Access Compliance Report Public Rights-of-Way (Curb Ramps)

Main Street: ROWENA_DR Cross Street: ST_CLOUD_DR Location: SW

ADA ID: RPRK211206141633 Ramp Type: Type 4 - Parallel Initial Pass/Fail: Fail Overall Compliance: No Severity Score: 15

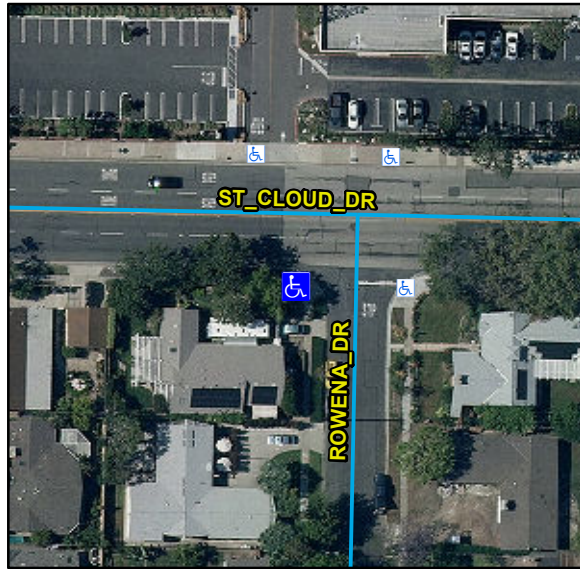
Compliance	Description	Data	Compliance	Description	Data
N/A	Ramp Length LT (in)	70	N/A	Ramp Length RT (in)	83
Yes	Ramp Width LT (in)	102	Yes	Ramp Width RT (in)	102
Yes	Ramp Run Slope LT (%)	7.2	Yes	Ramp Run Slope RT (%)	8.3
No	Ramp Cross Slope LT (%)	2.2	No	Ramp Cross Slope RT (%)	6.9
N/A	Landing Present	N/A	N/A	DWS Provided	N/A
N/A	Landing Length (in)	N/A	N/A	DWS Contrast	N/A
N/A	Landing Width (in)	N/A	N/A	DWS Length (in)	N/A
N/A	Landing Run Slope (%)	N/A	N/A	DWS Full Width	N/A
N/A	Landing Cross Slope (%)	N/A		DWS Offset Type	N/A
N/A	Landing Movement Obstructed?	N/A	N/A	DWS Offset Left (in)	N/A
	Landing Movement Type	N/A	N/A	DWS Offset Right (in)	N/A
N/A	Landing Shared	N/A			
N/A	Clear Space	Yes			
N/A	Clear Space To Crosswalk (in)	N/A			
N/A	Marked Crosswalk 1	No	N/A	Marked Crosswalk 2	No
	Crossing 1 Direction	E		Crossing 2 Direction	N
	Marked Crosswalk 1 Width (in)	N/A		Marked Crosswalk 2 Width (in)	N/A

Possible Solutions:

Remove & Replace Curb Ramp With Two New Directional Ramps or Equivalent.
